DESCRIPTION: Flip cap	CUSTOMER DRAWING	PRODUCT NUMBER: FC13 0009 Product Number old: KK1325
-----------------------	------------------	---

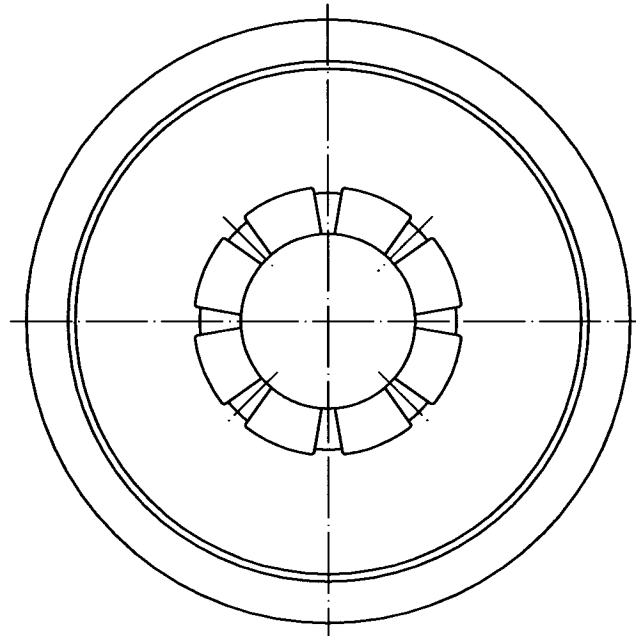
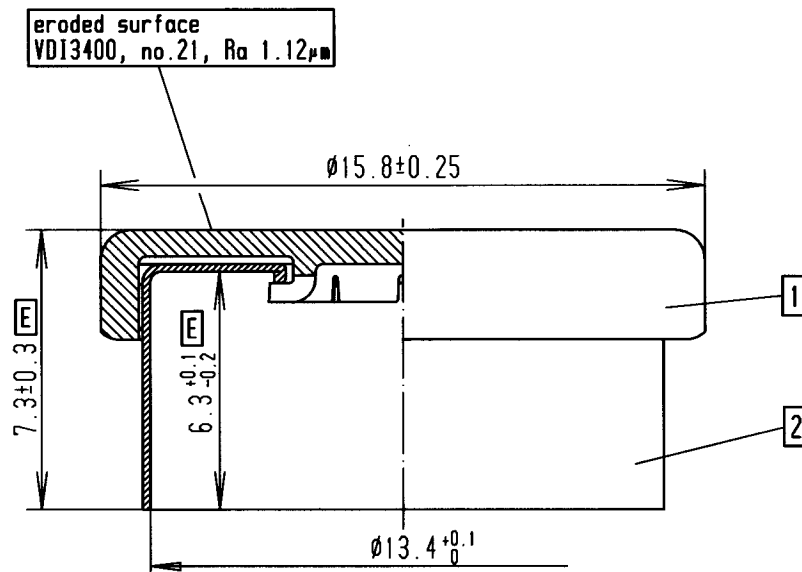
PARTS LIST						E	changed total-height 7.45±0.25 to 7.3±0.3, changed inner-height 6.35±0.2 to 6.3±0.1/-0.2.	21.11.11	Gilpert
						D	added text "eroded surface"	13.11.07	Gilpert
						C	changed tolerance Ø13.4±0.05 to Ø13.4±0.1/0.	22.05.07	Gilpert
						B	changed tolerance Ø13.4±0.1/0 to Ø13.4±0.05.	21.03.07	Gilpert
						A	total revision	05.10.05	Gilpert
	pos.	ref.no.	description	material	remarks	index	modification	date	name
	2	AHC13.0006	All alu-cap	AL (0.20±0.02)					
	1	PD13.0003	plastic disc	PP					
DRAWING	TRACED: Gilpert DATE: 21.11.11 CHECKED DATE 25.11.11 SIGNATURE: <i>Handwritten signature</i> SCALE: 5:1, 1:1								
	DERIVED FROM DRAWING KK1325			DATED 16.07.01		FILE-REF. (CAD-no.) B457K			PROJECTION:
	REPLACES PRODUCT DRAWING -----			DATED -----		MATERIAL: -----			
VALIDITY	VALID DATE 28. Nov 2011			AUTHORIZED by <i>G. Fehle</i>			SIGNATURE <i>J. Fehle</i>
